**Monks Orchard Residents' Association  
Planning Officer**

**Appeal Ref:** APP/L5240/W/23/3330711  
**LPA Reference:** 23/01204/FUL  
**Address:** Land Between 2-5 Round Grove Croydon CR0 7PP.  
**Proposal:** Demolition of detached building. Erection of 1 x two-storey two-bedroom detached dwellinghouse including new vehicular access and crossover, landscaping, boundary treatments, car parking, cycle parking and bin storage and all associated site works.  
**Case Officer:** Jessica Werrett  
**Consultation close:** 22nd March 2024

**Google Earth Image of Site showing actual boundary.**

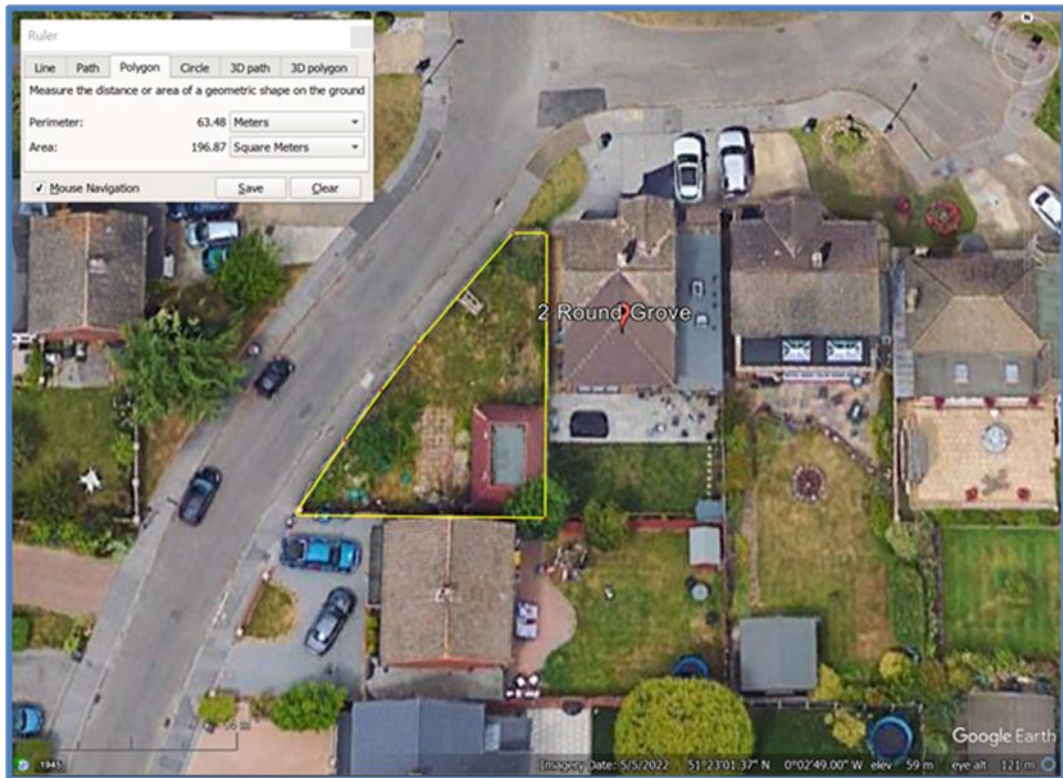
**1.1.1** The revised proposal parameters from our LPA Objection as a result of further assessment corrects earlier errors and compares the **Site Area** as stated on the Application form with an estimated measurement by use of Google Earth. The **Site Boundary (Red Line)** shown on supplied Block Plan drawing **4318/ PBP OS** includes a grass area beyond the **Boundary fence** which probably erroneously increases the **Site Area**.

The diagram identifies the perimeter **“Boundary”** Fence

4.2.5 The drawing clearly indicates that the **northern boundary** is squared off by an **existing boundary fence** and therefore the **Red Line** at the northern end of the **Plot** is probably **incorrect** and the site boundary should follow the boundary fencing. This can only be ascertained from **Title Deeds** of both **no. 2 & no. 5 Round Grove** to establish their **Registered boundaries**.

#### 3.3.2.2 **The appellant has provided additional swept path illustrations (Car Tracking Plots) at drawing 23.82 – 001 dated 11<sup>th</sup> Sept 2023.**

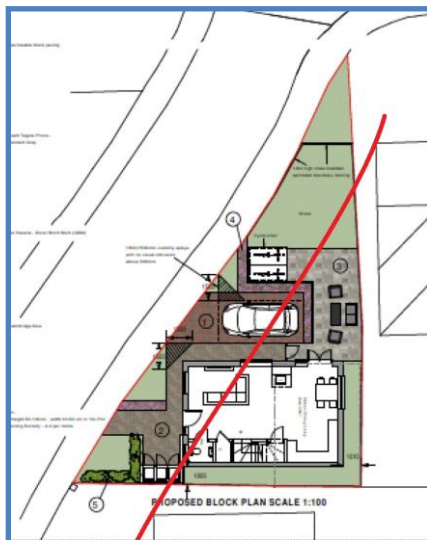
3.3.3 The swept path illustrations provided are for a small family car with an overall length of 4.8m and width 2m with a wheelbase of 2.9m width for front body overhang 0.9m and rear overhang of 1m.

3.3.3.1 There are three separate maneuvers depicted for entry and exit to the provided parking bay from Round Grove.

3.3.3.2 In the first illustration, the exit from a parked position in a forward gear shows the vehicle trajectory turning left out of the parking position with the forward steering wheels from 2m to approximately 2.5m then suddenly becoming 2m separation which is a physical trajectory whereby the tracking width between nearside and offside front wheels suddenly become much wider and then narrower – which is physically not feasible. There is an identical trajectory in the third illustration which is again an impossible path.

3.3.3.3 These impossible trajectories swept paths are evidence that the illustrations are not exact professional tracking software for swept path trajectories which gives suspicion on their validity.

3.3.3.4 We would therefore suggest that the entry into the Parking Bay from either direction from Round Grove would need to be by reversing from either the North or South into the Parking Bay such that the Position of the parked vehicle is facing the Round Grove for a forward Exit across the footpath for the safety of pedestrians.

3.3.3.5 It is probable that these maneuvers could not be achieved in a single direction but would require a reverse and forward maneuver of opposite lock to negotiate the entry or exit.

**Site Layout proposed showing existing Building Line Set-Back**

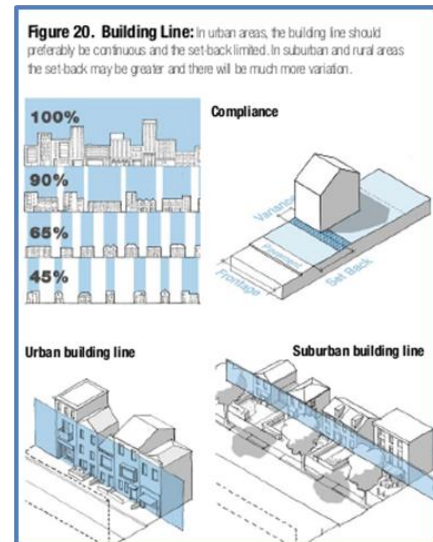
4.1 The proposed development does NOT observe or follow the established Building Line of Round Grove thus failing the National Model Design Code & Guidance. The Site Layout shows that the proposed development is forward of the existing building line as projected along Round Grove as illustrated by the RED line.
